November 29, 2018

**RE: Redtail Ranch Subdivision
Transportation Memo, El Paso County, CO**

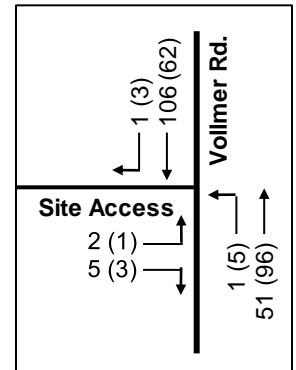
Address Vollmer Road pavement condition, width, shoulders... Are improvements necessary at the Sanctuary Pine intersection to bring Vollmer up to County criteria? Vollmer Road appears to be only 23 feet wide on the plans, without defined shoulders. Provide recommendations for pavement widening and shoulder improvements, both north and south of Sanctuary Pine Drive, to bring Vollmer Road up to ECM standards for the speed limit around the access for safety. (unresolved previous comments)
